# CITY PLAN COMMISSION STAFF REPORT

**Project Name**  
Twin Creeks Development Plan

**Request**  
CD-CPC-2024-00192  
Development Plan

Report Date: January 30, 2025  
Case Number: CD-CPC-2024-00192  
Project: Twin Creeks Development Plan

**1 LANDSCAPE AND TREE PRESERVATION PLAN**  
SCALE: 1"=50'-0"

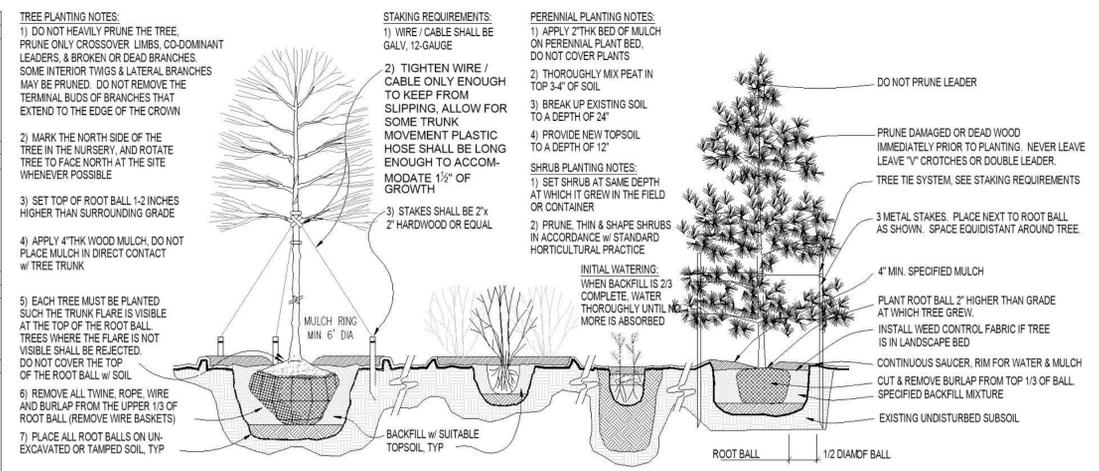
The applicant is providing landscaping in compliance with the Zoning and Development Code, including sufficient landscaping along North Madison Avenue. There is one outstanding correction regarding the type of trees provided along HWY 169 that will need to be resolved prior to ordinance request. Section 88-425-05-C requires a 10' (foot) wide buffer planted with enough Evergreen Shrubs for continuous screening, the submitted landscaping plan shows a line of what looks like Shademaster Honeylocust.

1. Provide a list of prohibited construction materials on the elevations. (1/21/2025)
2. Per 88-425-05-C, revise landscape buffer along HWY 169 to be 10 feet in width and planted with enough evergreen shrubs for a continual screening. (1/21/2025)
3. Provide a circulation plan for the entire development to ensure safe and efficient traffic flow. (1/21/2025)
4. The required parking numbers on the Development Summary Table are incorrect, review the parking ratio table for the proposed uses and update the table. (1/21/2025)

5. Include a note regarding the acreage of trees being preserved on the subject property on the landscaping plan. (1/21/2025)
6. Remove the "Overstory Trees (Tree Mitigation Requirements)" portion of the Landscape Schedule table. (1/21/2025)

Site Photometric  
Development Plans for:  
Twin Creeks  
Kansas City, Clay County, Missouri

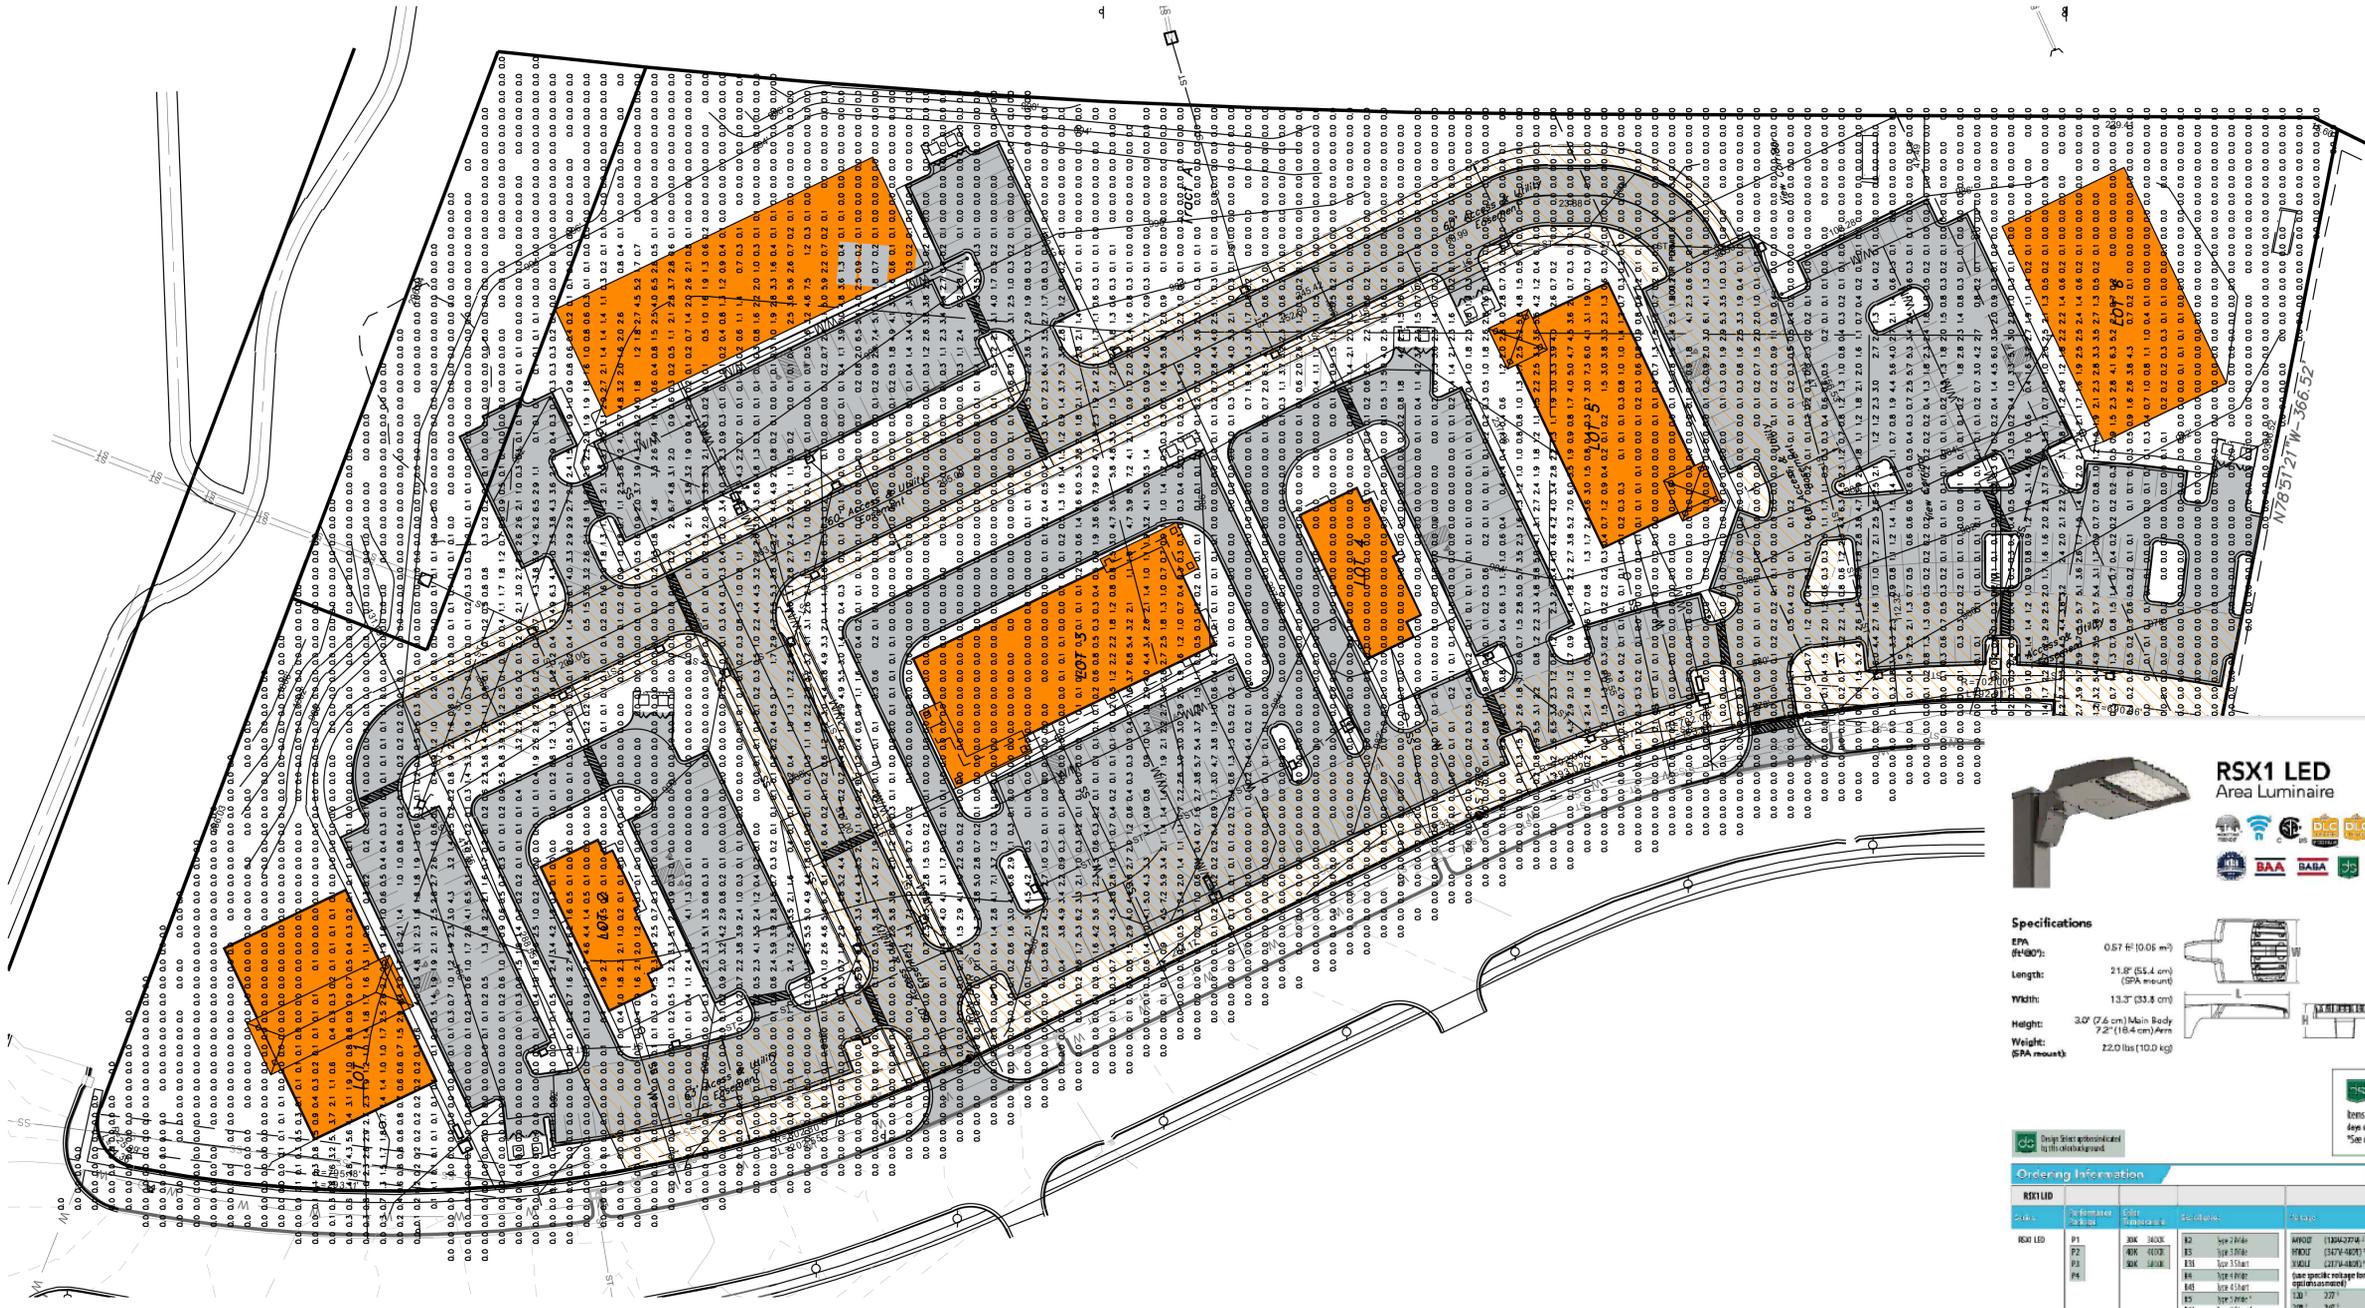
7. Identify the maximum height of plantings in close proximity to lighting elements. The mature height of these planting shall not impact or lessen the foot-candles shown on the approved photometric plan (Update 1-23-2025 - Landscape height not shown in landscape plan). (1/21/2025)
8. Consider changing light fixtures or adding lighting in the parking lots. According to the Illumination Engineering Society (G-1-22) standards - A retail store/medical offices should have an average maintained footcandle reading of 3 in parking areas/sidewalks/entry areas with an average to minimum ratio of 4:1 (Update 1-23-2025 - Update Photometric plan to ensure all new lighting in appropriated marked). (1/21/2025)
